Access Compliance Report

Public Rights-of-Way (Curb Ramps)

Intersection ID: 28932	Main Street: GIBBONS_LINK_RD	Cross Street: BRANDIE_GLEN_RD	Location: S
ADA ID: 544A97C8CBF3	Ramp Type: PerpDiag	Initial Pass/Fail: Fail	Overall Compliance: No
Severity Score: 13.75			
Codes/Mitigation Info/Possible Solution		Field Measurements/Component Compliance

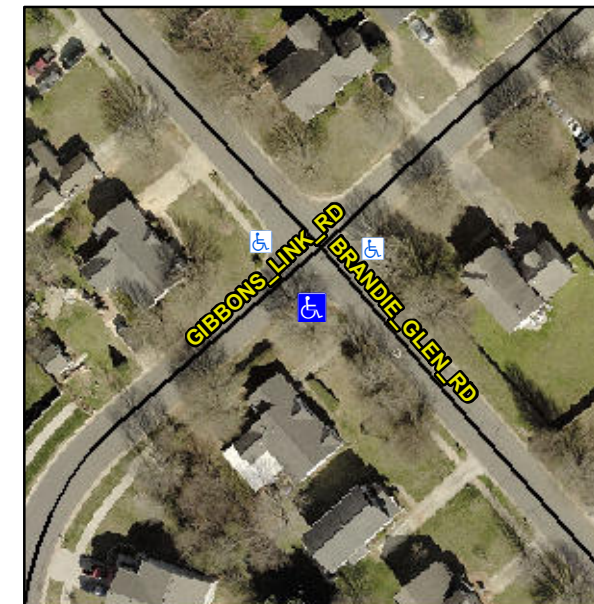
Compliance	Description	Data	Compliance	Description	Data
N/A	Ramp Length (in)	48.5	No	Ramp Slope (%)	10.1
Yes	Ramp Width (in)	48.5	No	Ramp XSlope (%)	3.3
N/A	Flare Type LT	N/A	N/A	Flare Type RT	N/A
N/A	Flare Slope LT (%)	N/A	N/A	Flare Slope RT (%)	N/A
N/A	Flare Traversable LT?	N/A	N/A	Flare Traversable RT?	N/A
N/A	Landing Length (in)	N/A	N/A	DWS Provided?	N/A
N/A	Landing Width (in)	N/A	N/A	DWS Contrast?	N/A
N/A	Landing Slope (%)	N/A	N/A	DWS Length (in)	N/A
N/A	Landing X Slope (%)	N/A	N/A	DWS Full Width?	N/A
N/A	Landing Curb? (Y/N)	N/A	N/A	DWS Offset (in)	N/A
N/A	Shared Landing?	N/A			
N/A	Gutter Ponding?	N/A	N/A	Gutter Slope (%)	N/A
N/A	Gutter Lip Ht (in)	N/A	N/A	Gutter X Slope (%)	N/A
N/A	Painted X Walk1?	No	N/A	Painted X Walk2?	No
	X Walk 1 Direction	To NE		X Walk 2 Direction	To NW
N/A	X Walk 1 Width (in)	N/A	N/A	X Walk 2 Width (in)	N/A
	X Walk 1 Slope (%)	3.3		X Walk 2 Slope (%)	2.6
	X Walk 1 X Slope (%)	2.0		X Walk 2 X Slope (%)	3.8

N/A	Ramp inside XWalk1?	N/A	N/A	Ramp inside XWalk2?	N/A
	Road Slope (%)	4.7	N/A	Clear Space?	N/A
	Road X Slope (%)	1.7	N/A	Clear Space to XWalk (in)	N/A
N/A	Any Obstructions?	N/A	N/A	Storm Grate/Utility Hazard?	N/A
	Obstruction Type			Storm Grate/Utility Type	
		N/A			N/A
			Yes	Surface Condition? (G/P)	Good

Remove & Replace Curb Ramp With Two New Directional Ramps or Equivalent.
